Submittal Detail

SB 1022 Classroom and Vocational Training Center Project

SUB-13 34 19-2-009		Rev: 0	Stage:	Closed
Assigned To				
Bid Package	Trade Contact	Trade Company	Due to CM	
BP-02A-Gilbane Kitchell CPM	Starr, Cameron		09-01-2017	
Register Item Information				
Description				
Mezzanine Shop Drawings rev				
CSI Code	Sub Section	Туре	Category	
133419		Shop Drawing	For Approval	
Notes

SUPPORT PLATFORM

SHEET NUMBER:

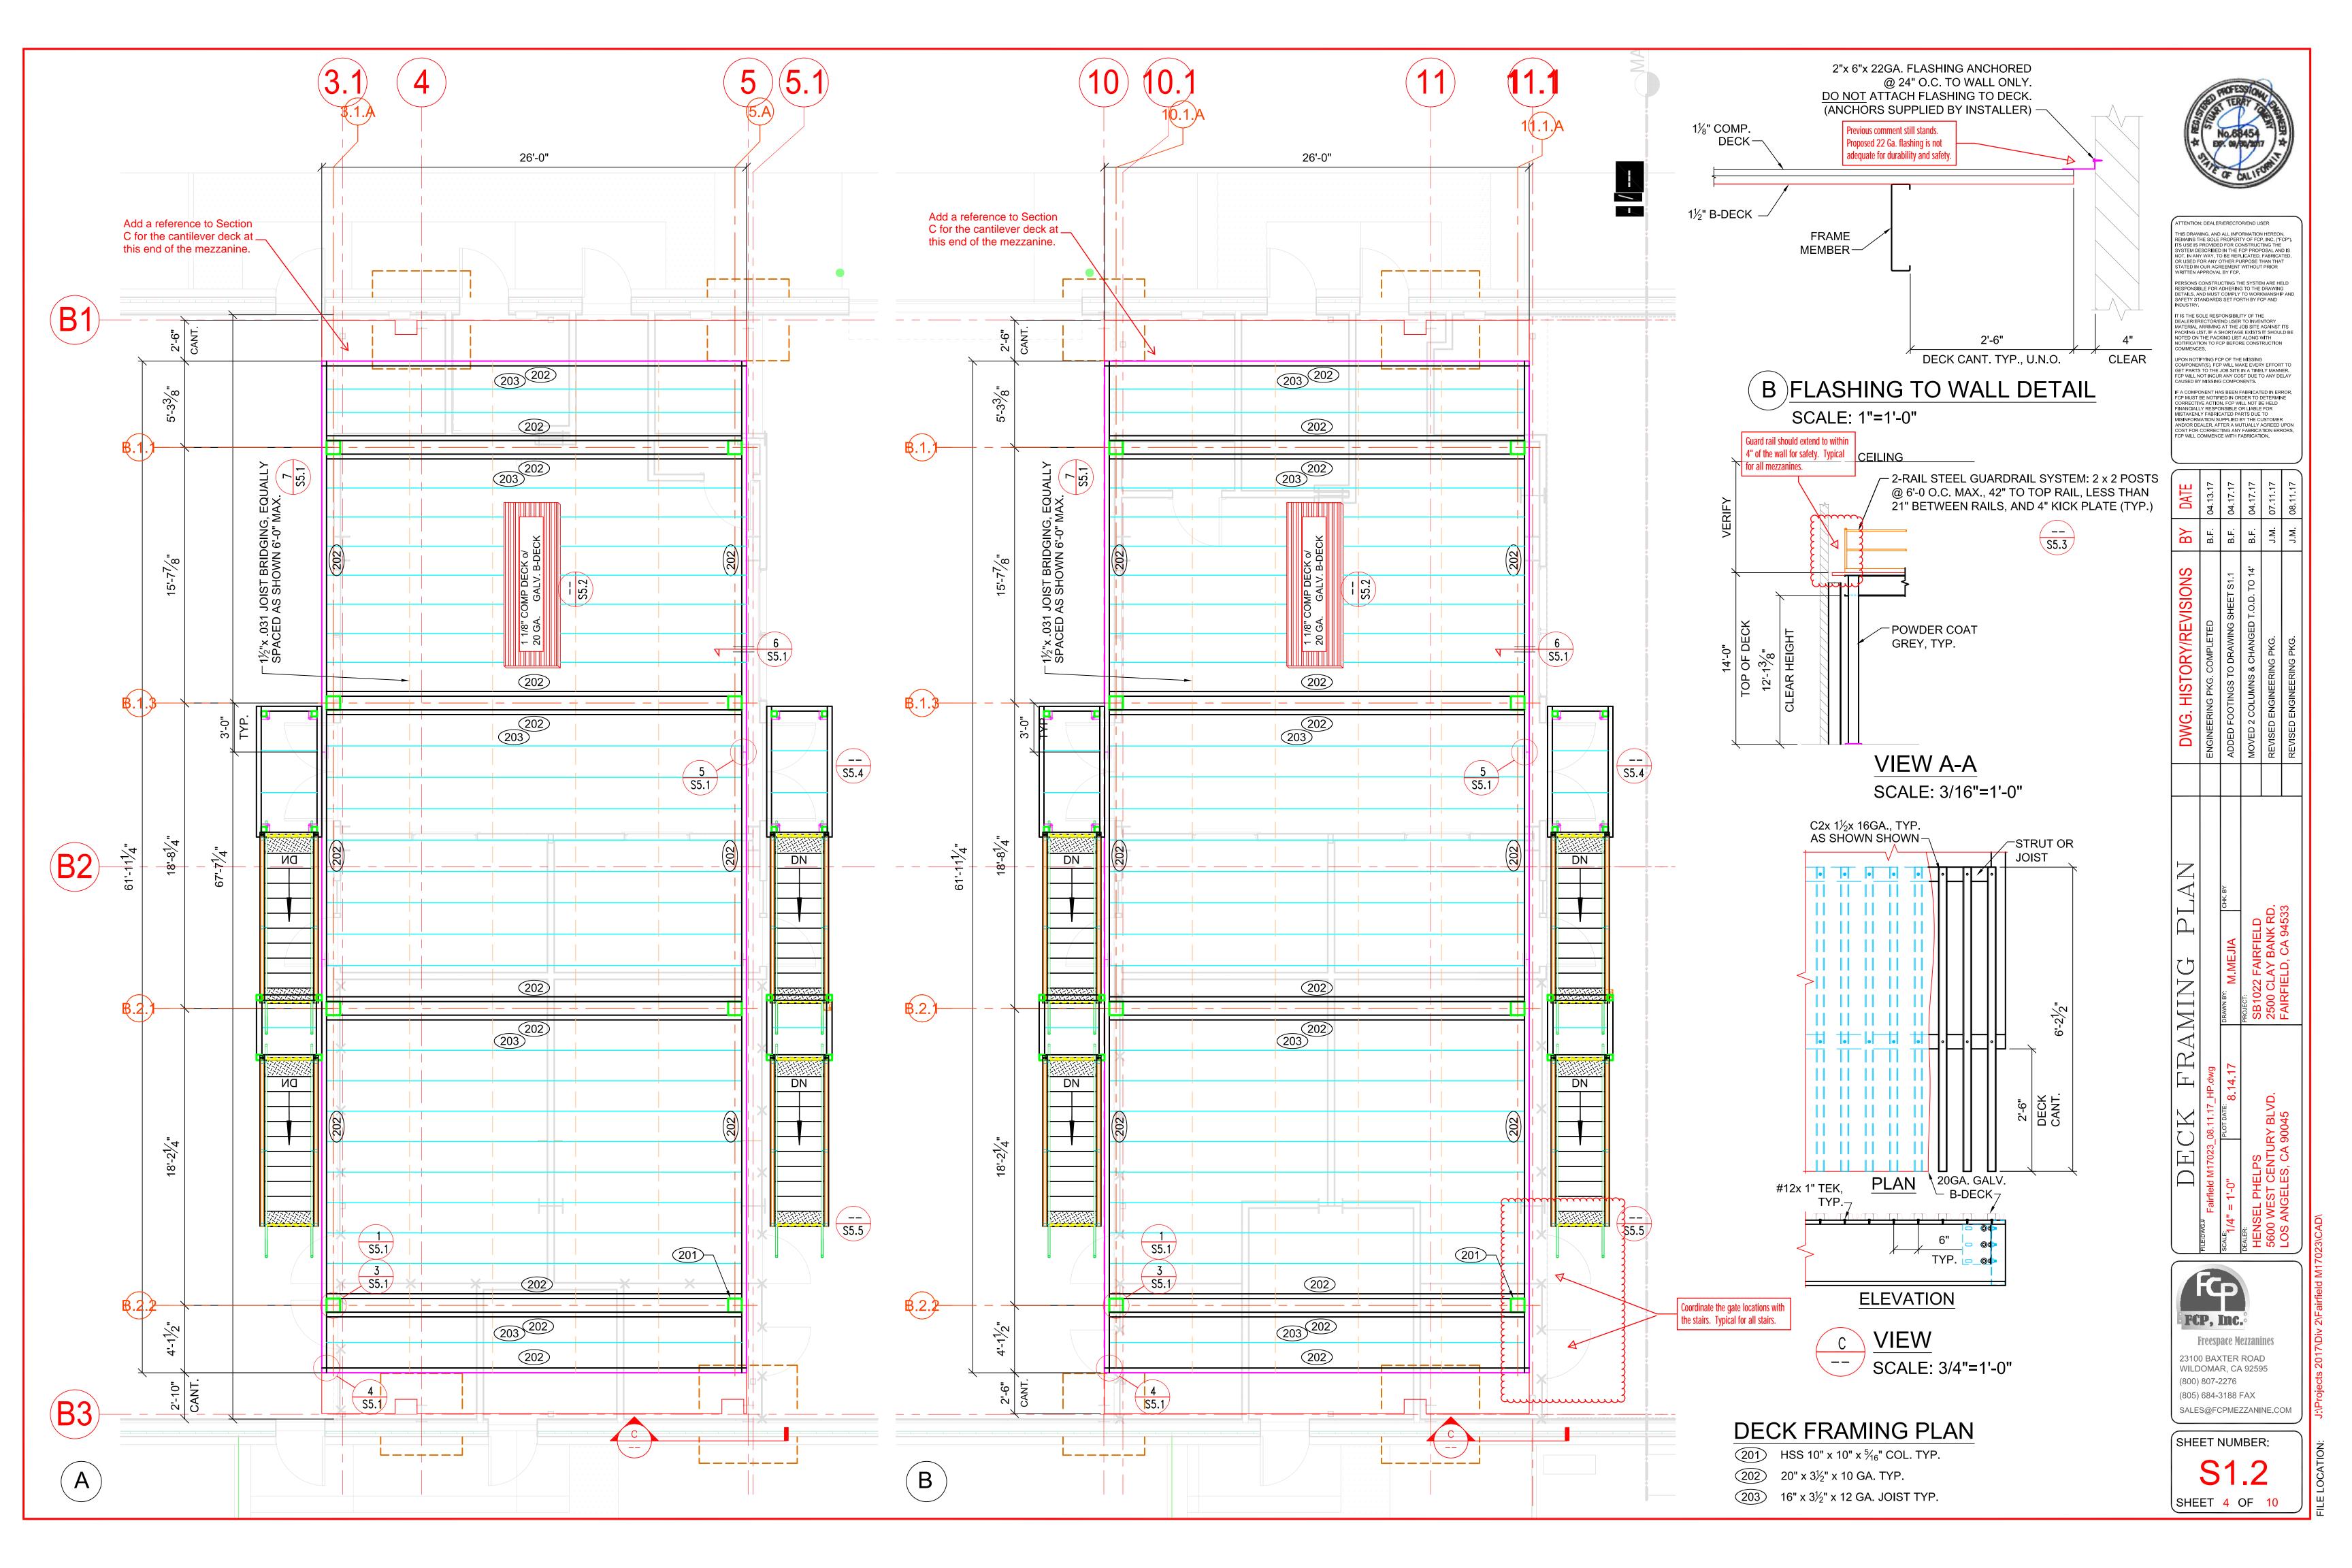
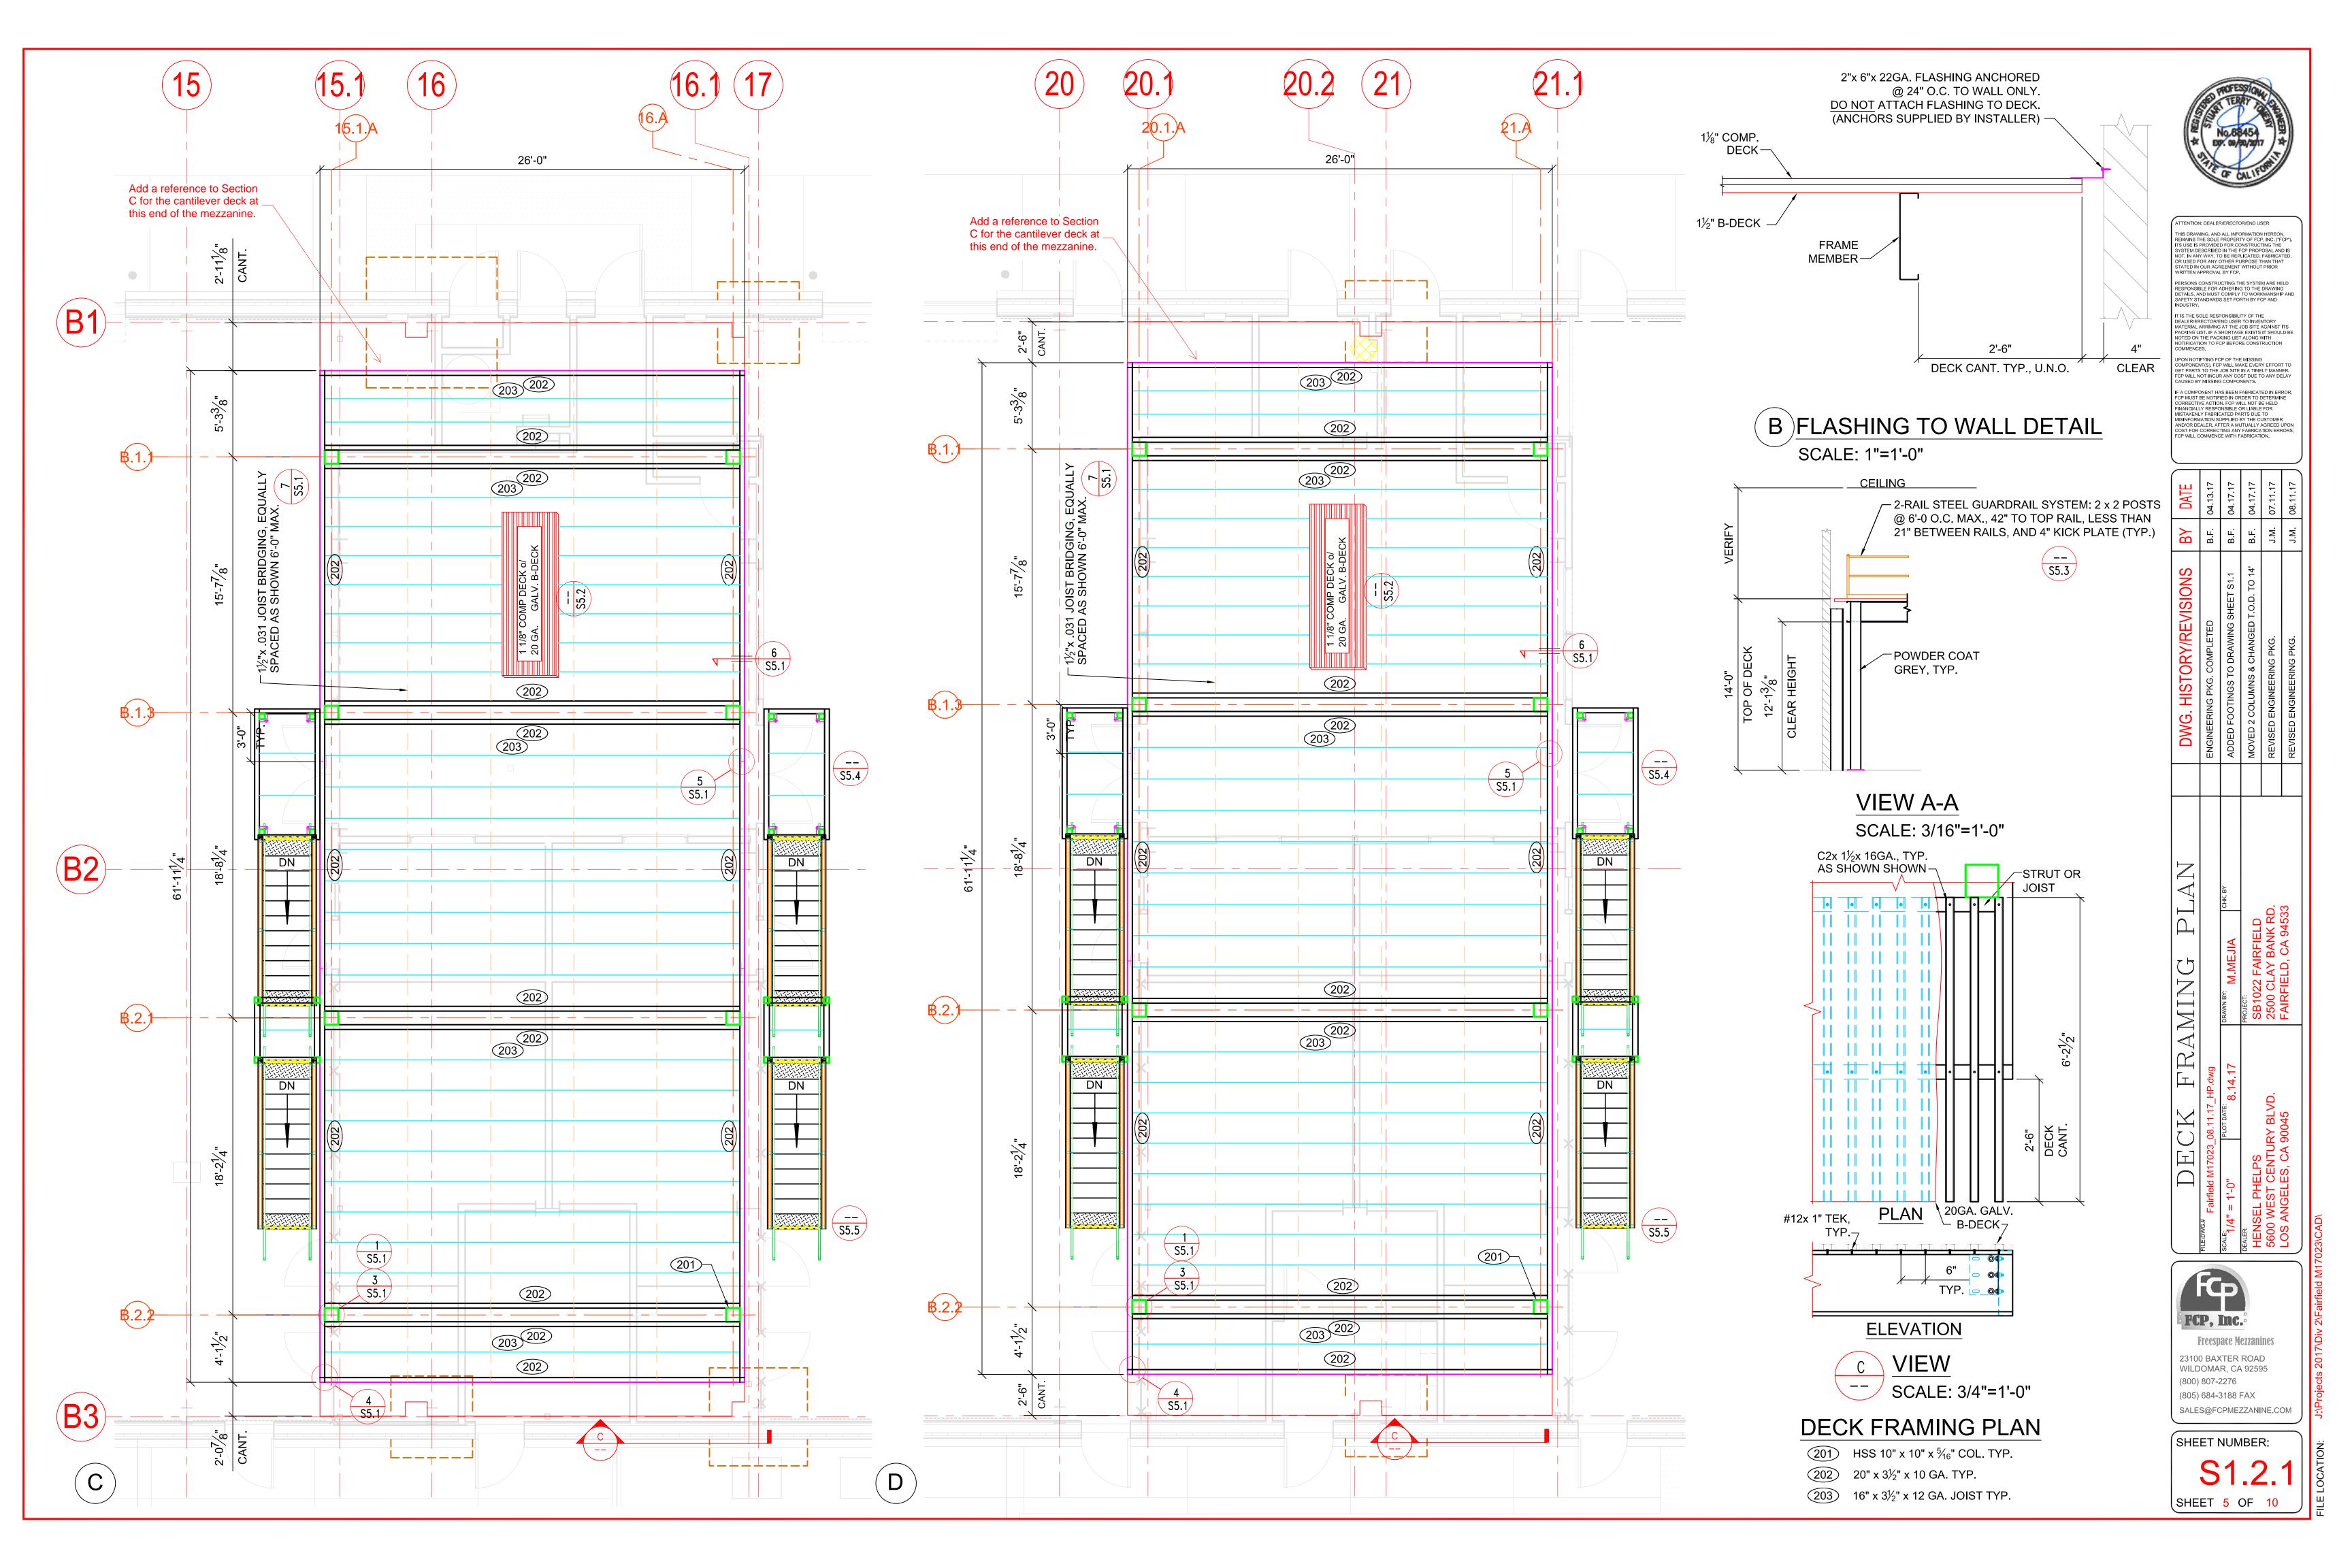
Coordinate all mechanical openings and mechanical equipment structural support with new designed structural system including but not limited to penings indicated on shop drawings.

> 2013 per structural calculations; revise

Factor is 1.25 per LIGHT STORAGE the structural **SPECIFIC USE:** calculations: revise

The design soil pressure is 2500 psf

2. 6" SLAB per the structural calculations; revise.

The slab is 5" at the mezzanine or 3. 2500 PSI CONCRETE -6" outside of the mezzanine area

- see sheets S202 and S203. 4. BUILDING TYPE:

ALL STRUCTURAL STEEL SECTIONS AND WELDED PLATE MEMBERS SHALL CONFORM TO ASTM A36 UNLESS NOTED AS GR.50 ON THE PLANS, IN WHICH CASE THEY SHALL CONFORM TO ASTM A572, STRUCTURAL STEEL TUBING SHALL CONFORM TO ASTM A-500 GRADE "C". STEEL PIPE COLUMNS SHALL BE GRADE "B" CONFORMING TO ASTM A53. ALL PRIMARY AND SECONDARY FRAMING MEMBERS ARE FABRICATED FROM ASTM A653 GRADE 55 (Fy-55 KSI. MIN.) AND ARE G60 Verify ASTM A-500 grade "C" is available for the steel

tubes. AISC Table 2-3 noted that this grade should be checked for availability prior to specifying its use.
